**RECOMMENDATION OF THE
URBAN COUNTY PLANNING COMMISSION
OF LEXINGTON AND FAYETTE COUNTY, KENTUCKY**

IN RE: NPE 2021-1: UK FEDERAL CREDIT UNION (QUEEN ESTATE) – a petition for an amendment to Section 10 of the Newtown Pike Extension Ordinance (Ord. #105-2009) for property located on 603 – 619 S. Broadway and 405 – 411 Chair Avenue. (Council District 3)

NPE 2021-1: UK FEDERAL CREDIT UNION (QUEEN ESTATE)

Fig. 18 Transparent Screen Wall Example

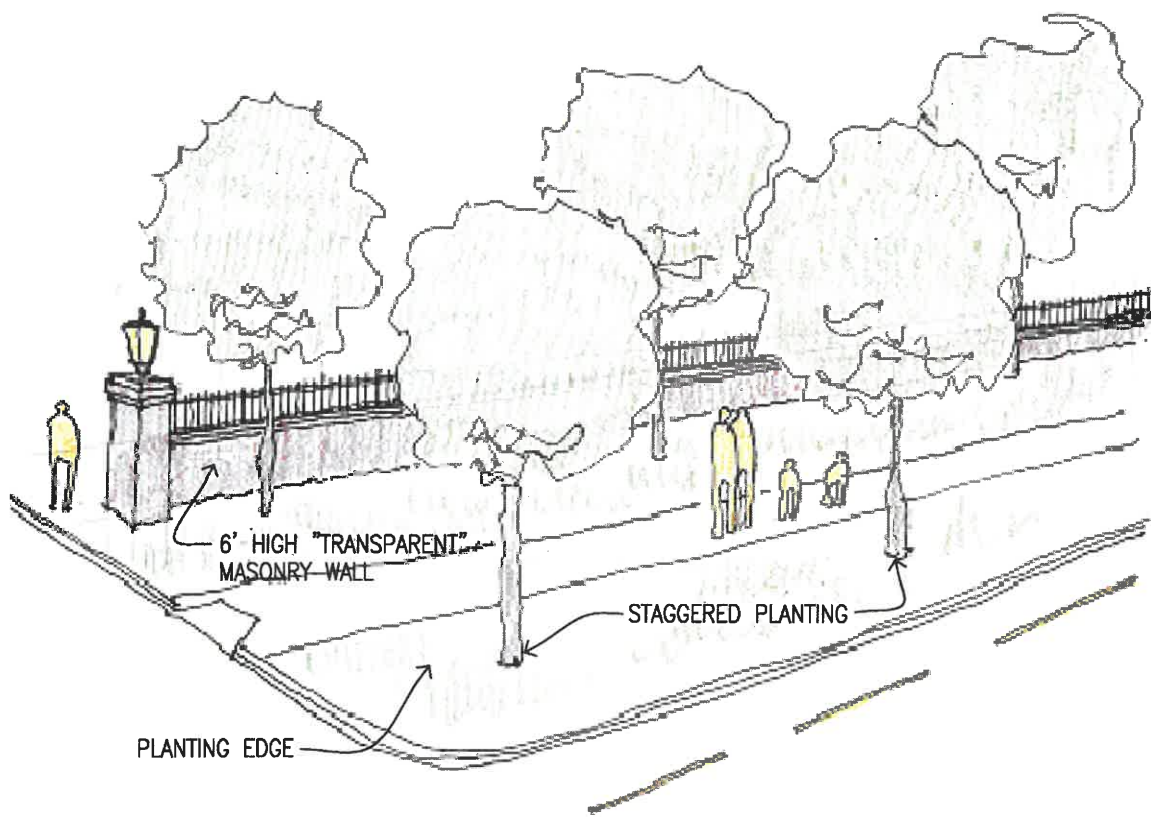
This requirement states “parking lots along street frontage shall be screened with a 6 foot high brick, natural stone or cut stone masonry screen wall.” The standard goes on to specify that the walls must be opaque at least 30 inches from grade. These screening requirements are for surface parking lots that are located adjacent to, and visible from, the Oliver Lewis Way corridor (formerly Newtown Pike Extension). In general, the standards are designed such that buildings will be located adjacent to the roadway and parking lots will be designed to be behind the buildings, or intense screening of the parking will be provided, if not behind the building. Example screening walls are depicted in Figures 17 and 18 of the Standards.

In reviewing the applicant’s request, staff believes the current design standard addresses their stated concerns, and no relief is necessary. The key requirement is that the wall be opaque a minimum of thirty inches from grade. That leaves an additional forty-two inches that can be “transparent” utilizing wrought iron railing or similar treatment for the remainder of the wall (see Exhibit 18 attached). This design, when utilized with landscaping, will be welcoming, allow visibility and discourage negative impacts while protecting the aesthetics of the landscaping.

The Staff Recommends: Disapproval of the elimination of the parking lot screening standard C-1(c), for the following reasons:
